# **Perth Metropolitan Desalination Proposal – Water Quality Management, Change to Implementation Conditions**

**Section 46 Report and recommendations  
of the Environmental Protection Authority**

**Environmental Protection Authority  
Perth, Western Australia  
Report 1327  
May 2009**

Assessment No. 1570

**Figure 3: Bottom water daily median DO concentrations for period May 2005 to May 2006**

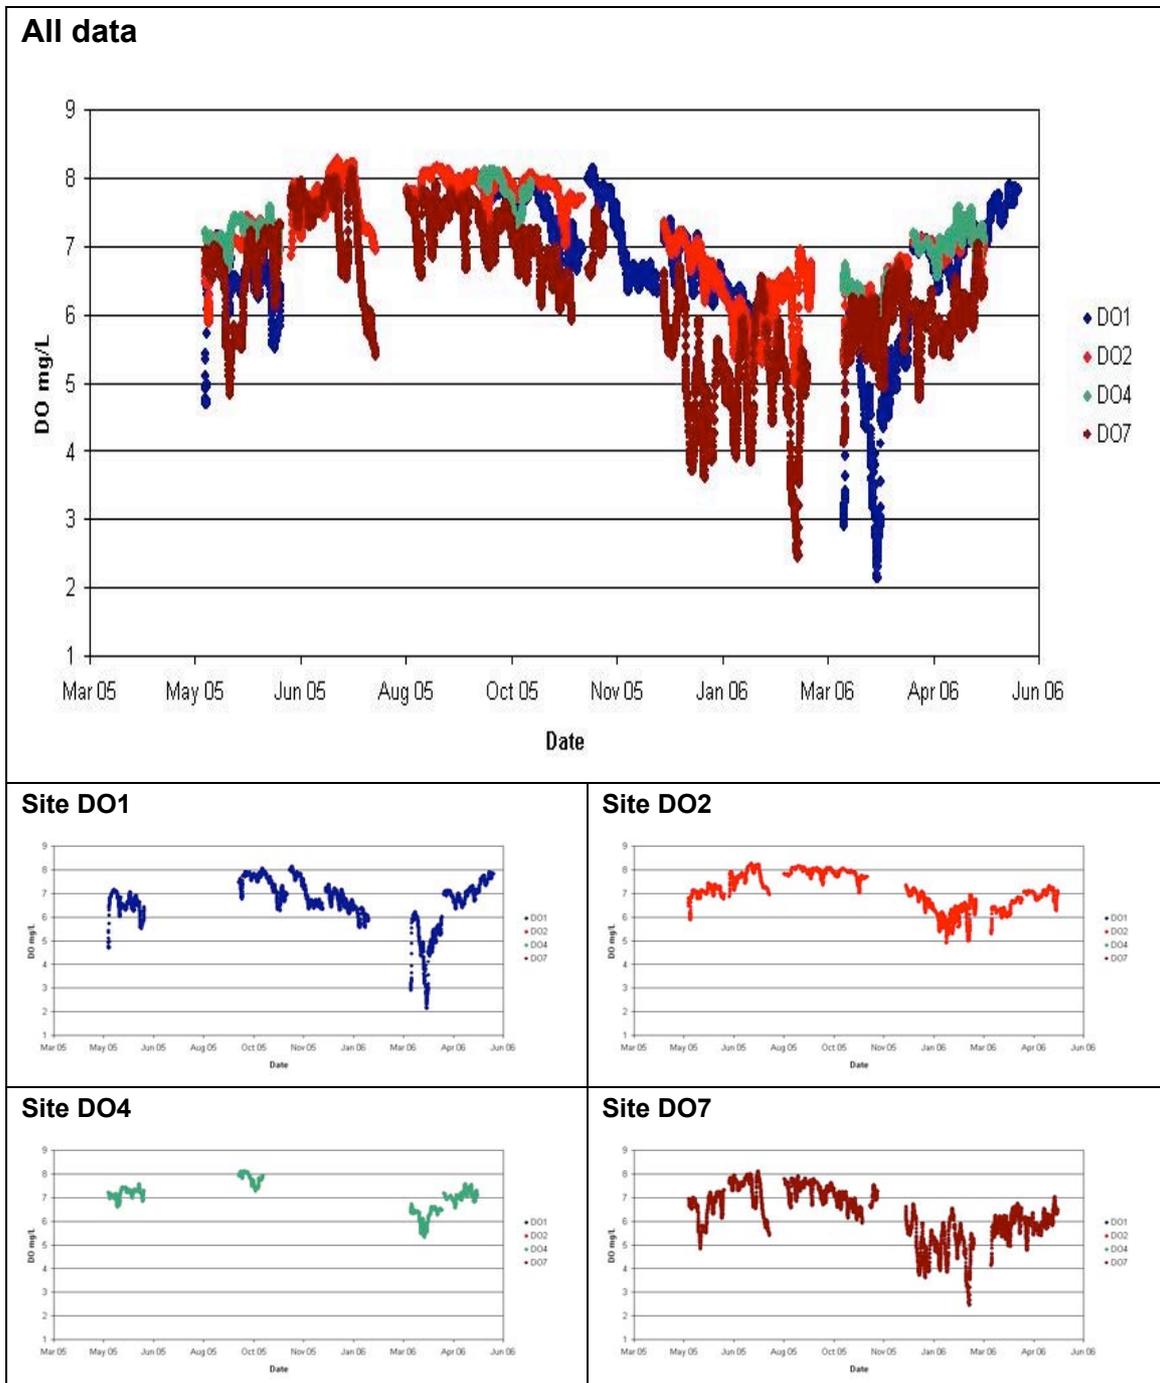
The Panel notes that these data (Figure 3) are patchy in that some sensors were not working routinely. The Panel understands that the problems have been largely overcome and these sensors are now working well.

Figure 3 shows a seasonal pattern in the bottom water DO concentrations in Cockburn Sound where low DO concentrations occur in summer through autumn. In 2005 the lowest DO was 4.2 mg/L (57 percent saturation) at site DO1 and 4.5 mg/L

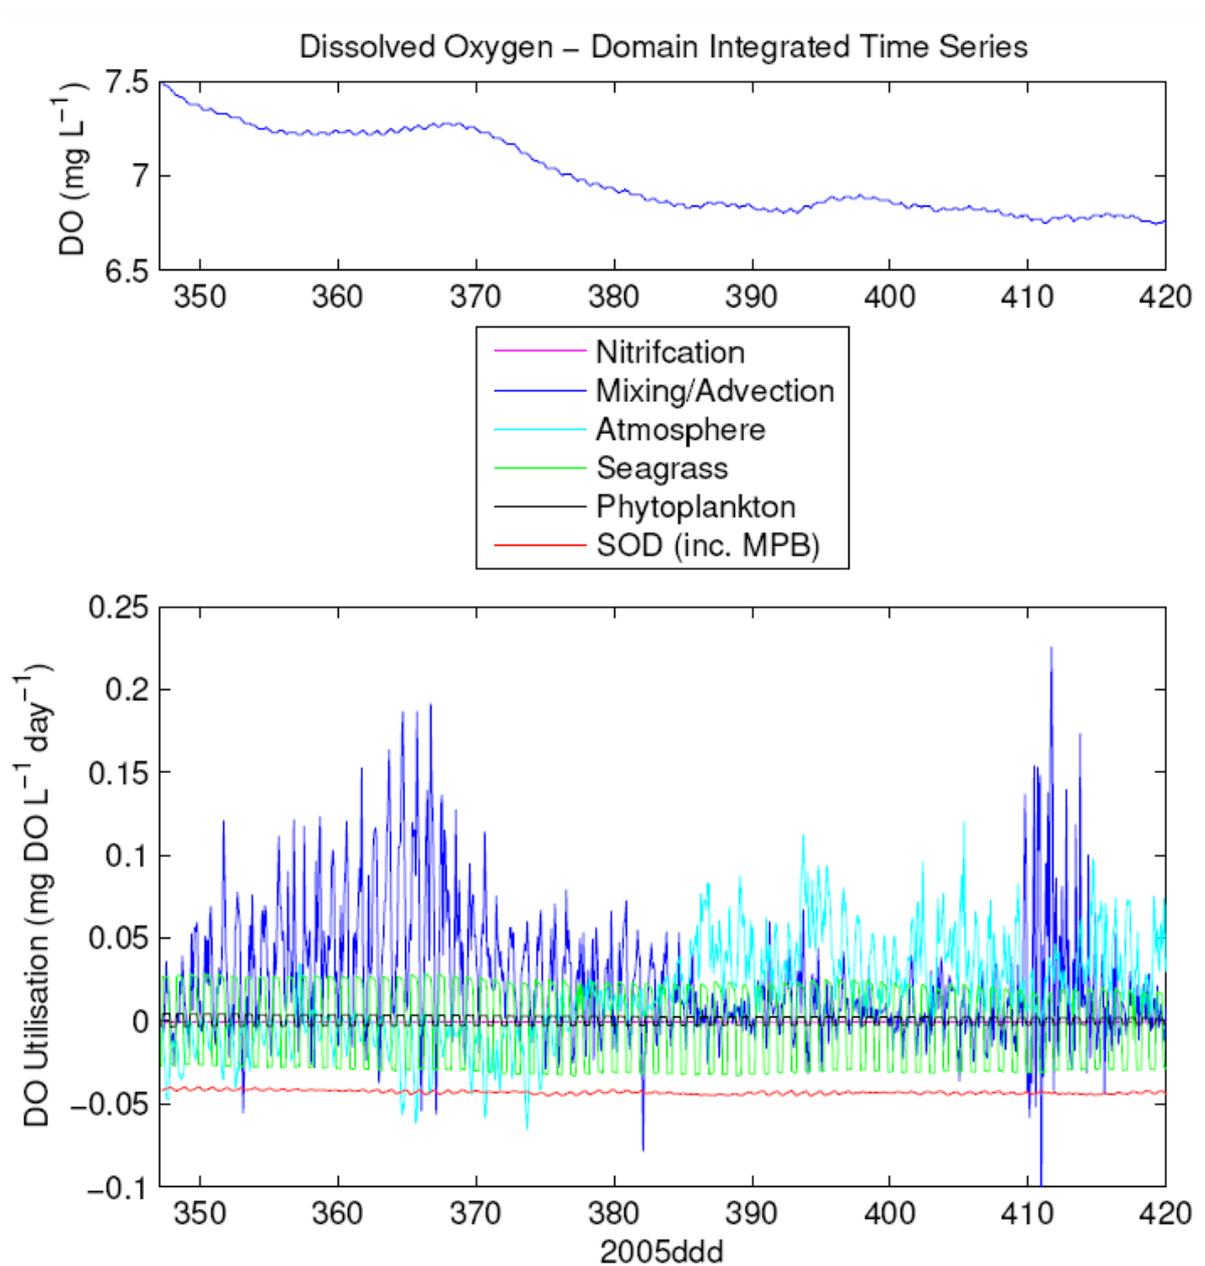
The report acknowledges that only a small amount of data are available with which to calibrate parameters associated with phytoplankton and nutrient cycles. It makes the point that this is not a critical issue for this application, given that oxygen concentrations are the main focus of the study and that these are dominated by the three processes listed above. This assertion is well supported by their Figure 5.2 (reproduced as Figure 7 of this report), and I think it is a reasonable assertion.

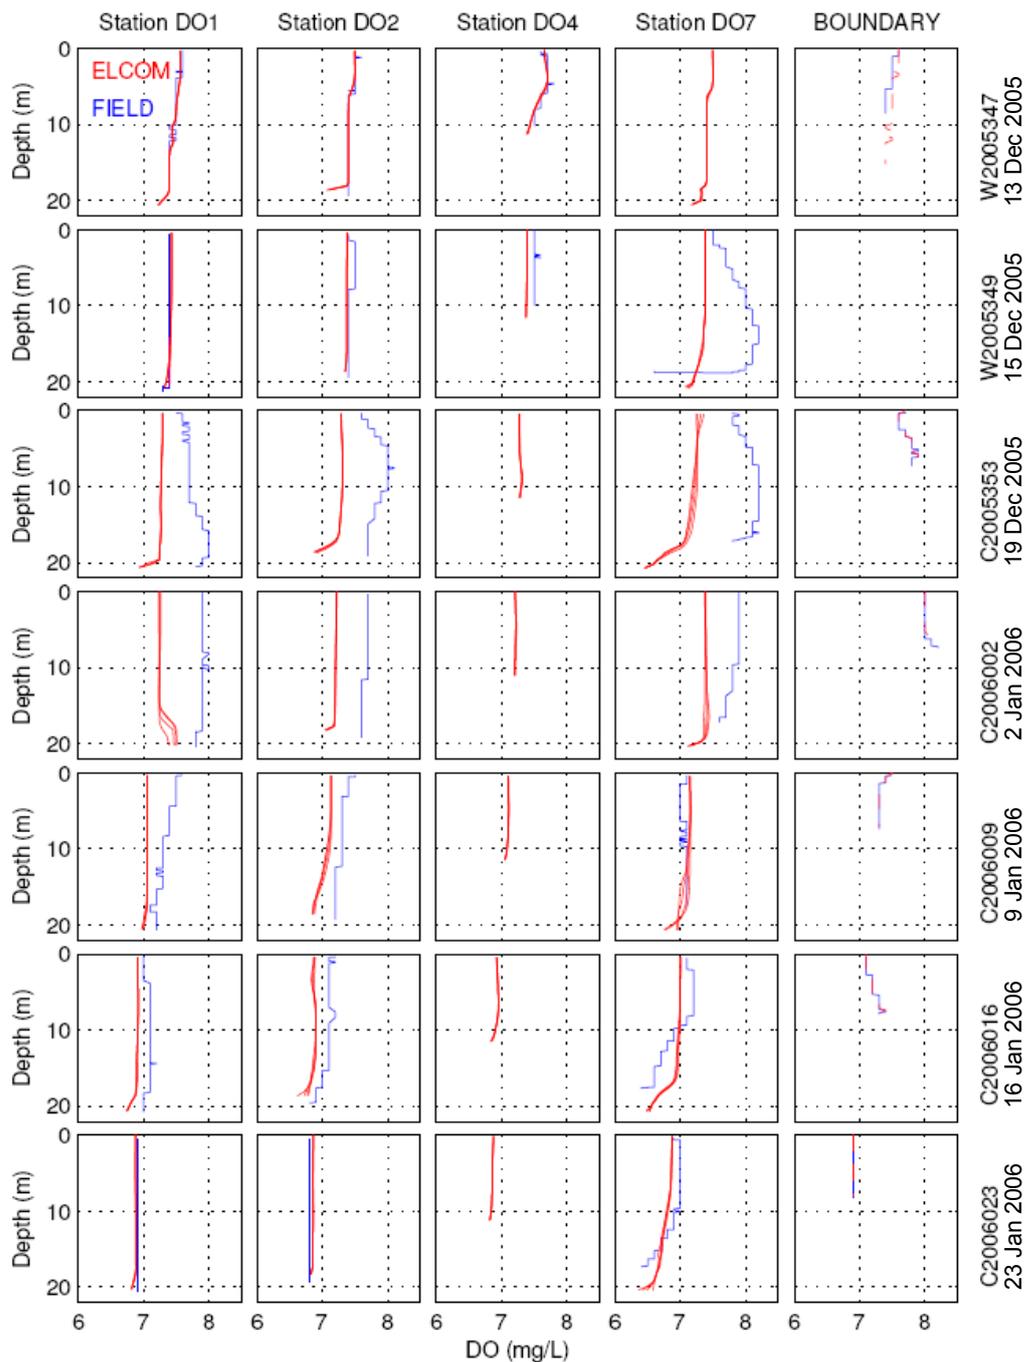
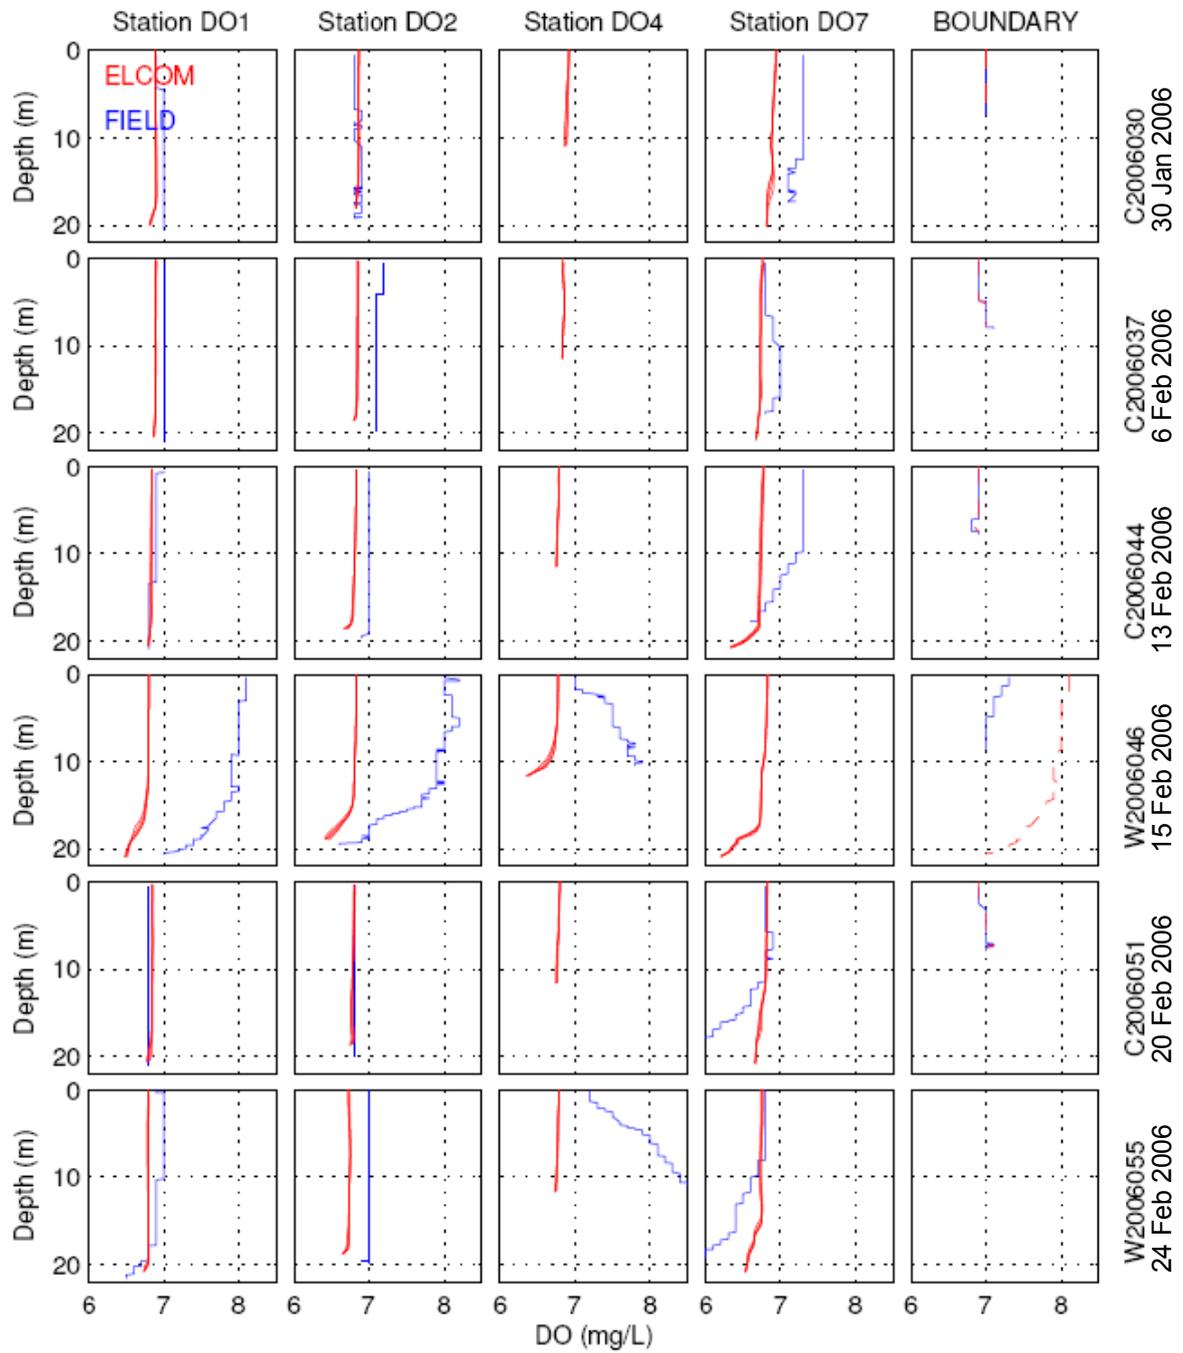
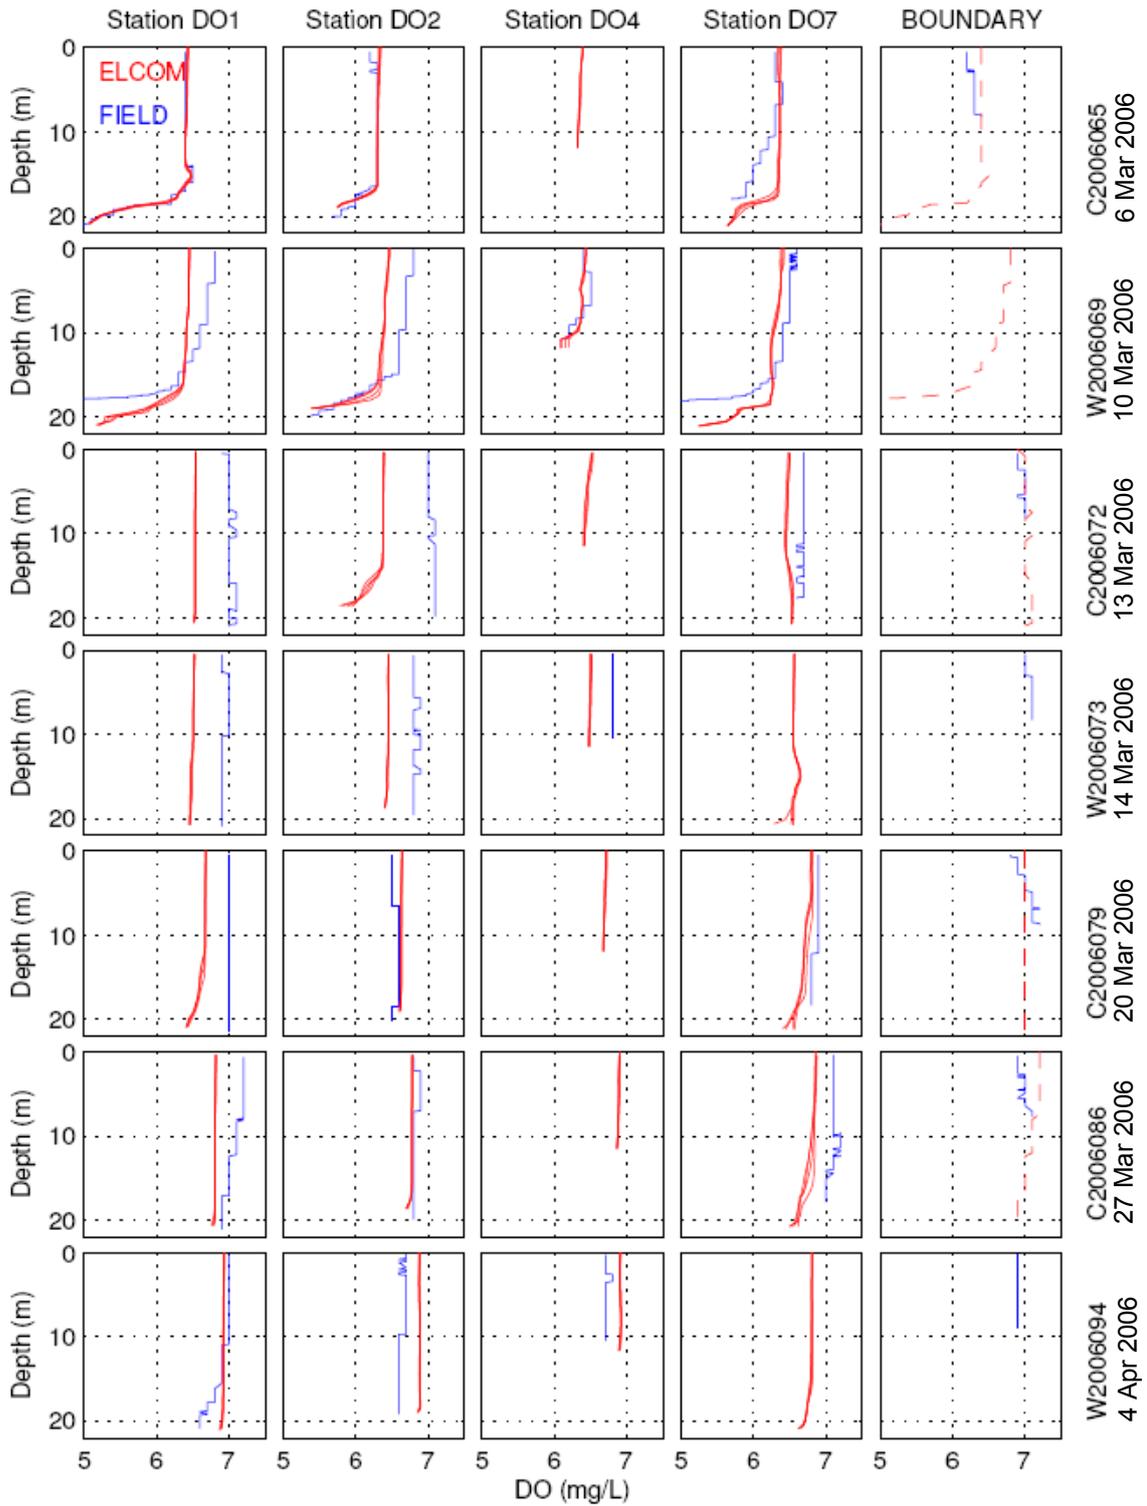
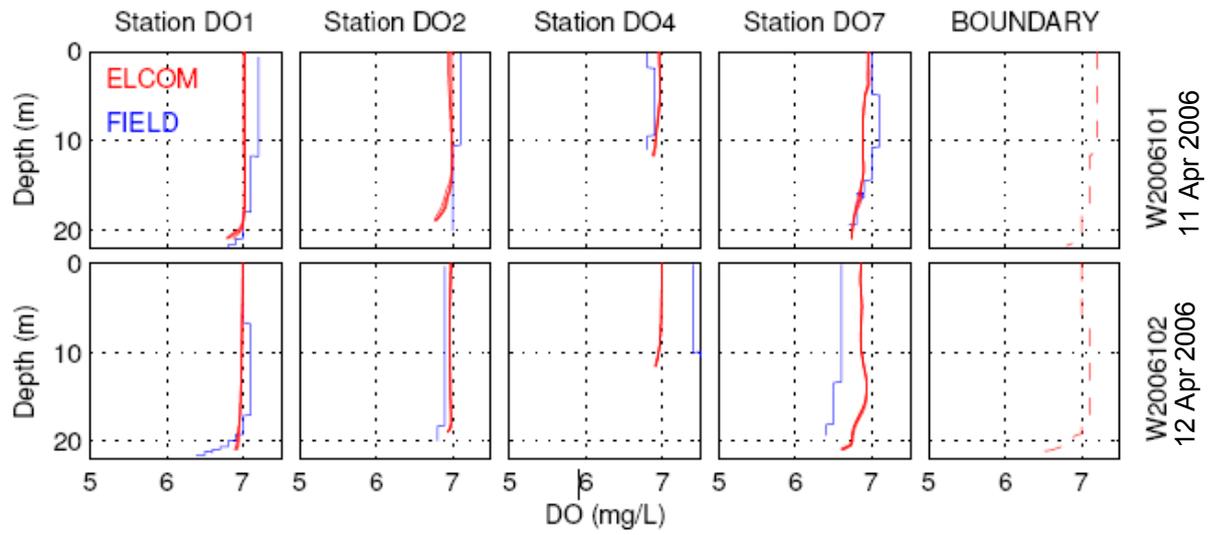
Dates for which profiles were available for validation are given in Appendix B of this report. In contrast to the validation for the hydrodynamic model (discussed in Section 4.3), there are several dates for the critical autumn period, although they do not extend into May. The comparison between measured and predicted profiles is shown mainly in Figures 5.4, 5.5, 5.8 and 5.9 of Appendix 5 (reproduced in Figure 8 of this report). With regard to the summer period (January-February), the report states (p. 18) that there is “generally ... good correlation between the measured and simulated results at all sites, with absolute values and the nature of the vertical stratification captured,” although it does note that there are problems on some days. With regard to the autumn period (March-April) the report states (p. 24) that the “simulation results show

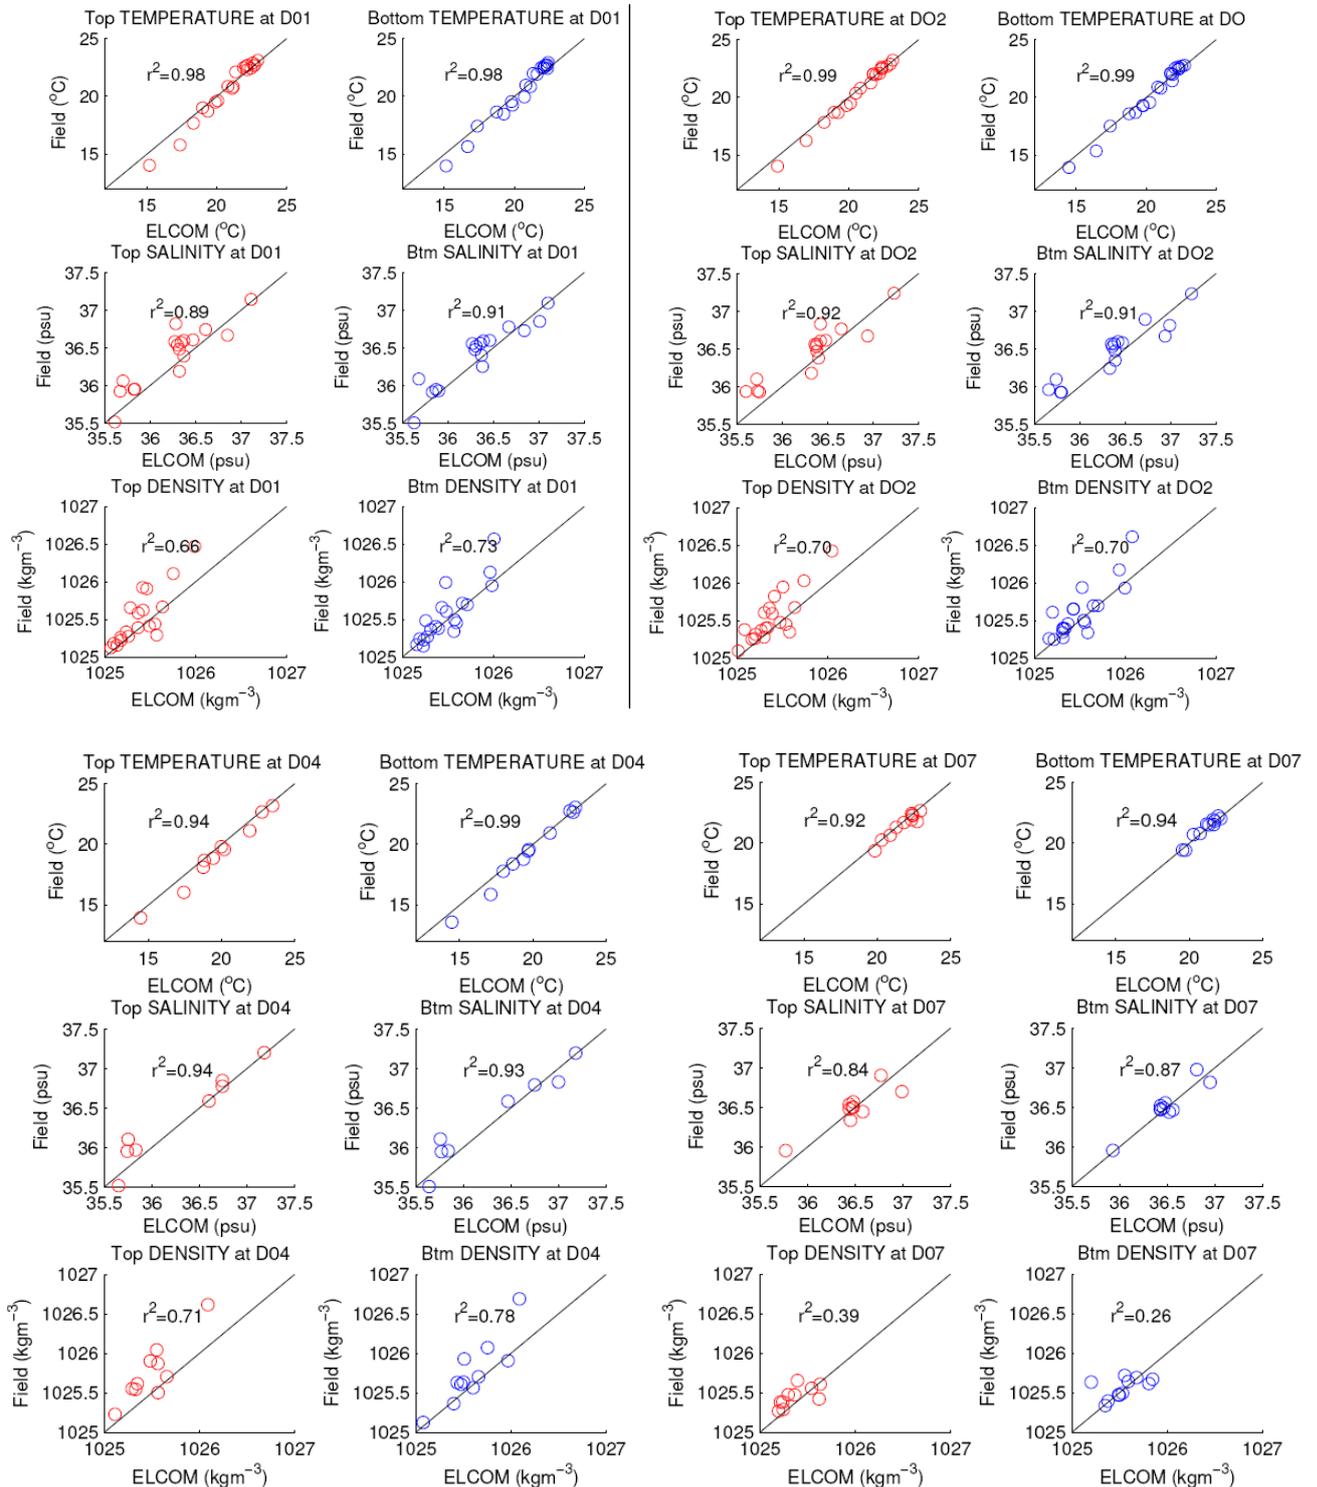
Quantitative measures of goodness-of-fit between predicted and measured values were given as correlation coefficients and presented in scatter plots (Section 5.1.5, Appendix 6; shown in Figure 12 of this report). As for oxygen, however, no statistical measures were computed that would allow quantitative estimates to be made of the level of precision of model predictions that one could have confidence in. Derivation of error estimates is becoming more common in lake and ocean modelling now (Willmott et al. 1985, Smith and Rose 1995, Holt et al. 1995, Rueda and Schladow
